Access Compliance Report

Public Rights-of-Way

(Curb Ramps)

Intersection ID: 11226	Main Street: AIRLIE_ST	Cross Street: EASTWOOD_DR	Location: E
ADA ID: B8B802932F4D	Ramp Type: Perp	Initial Pass/Fail: Fail	Overall Compliance: No
Severity Score: 13.75			
Codes/Mitigation Info/Possible Solution		Field Measurements/Component Compliance

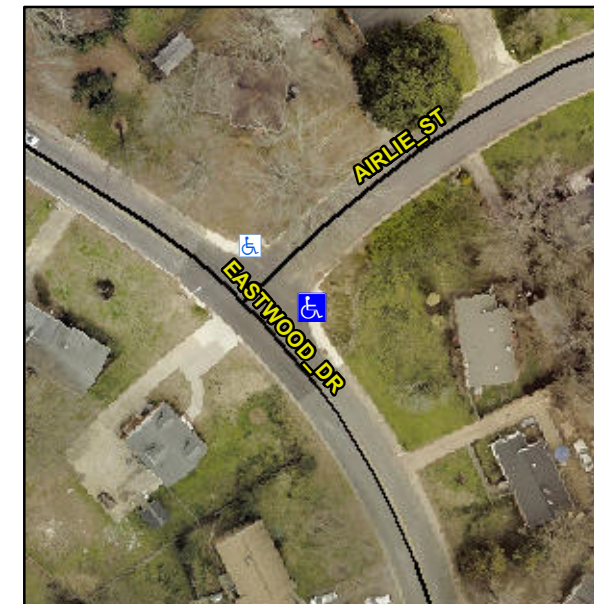
Not Found, R304.2.2, R304.5.3

Compliance	Description	Data	Compliance	Description	Data
N/A	Ramp Length (in)	47.5	No	Ramp Slope (%)	10.7
Yes	Ramp Width (in)	48.5	No	Ramp XSlope (%)	2.7
N/A	Flare Type LT	N/A	N/A	Flare Type RT	N/A
N/A	Flare Slope LT (%)	N/A	N/A	Flare Slope RT (%)	N/A
N/A	Flare Traversable LT?	N/A	N/A	Flare Traversable RT?	N/A
N/A	Landing Length (in)	N/A	N/A	DWS Provided?	N/A
N/A	Landing Width (in)	N/A	N/A	DWS Contrast?	N/A
N/A	Landing Slope (%)	N/A	N/A	DWS Length (in)	N/A
N/A	Landing X Slope (%)	N/A	N/A	DWS Full Width?	N/A
N/A	Landing Curb? (Y/N)	N/A	N/A	DWS Offset (in)	N/A
N/A	Shared Landing?	N/A			
N/A	Gutter Ponding?	N/A	N/A	Gutter Slope (%)	N/A
N/A	Gutter Lip Ht (in)	N/A	N/A	Gutter X Slope (%)	N/A
N/A	Painted X Walk1?	No	N/A	Painted X Walk2?	N/A
	X Walk 1 Direction	To NW		X Walk 2 Direction	N/A
N/A	X Walk 1 Width (in)	N/A	N/A	X Walk 2 Width (in)	N/A
	X Walk 1 Slope (%)	0.8		X Walk 2 Slope (%)	N/A
	X Walk 1 X Slope (%)	1.0		X Walk 2 X Slope (%)	N/A

Remove & Replace Entire Ramp.
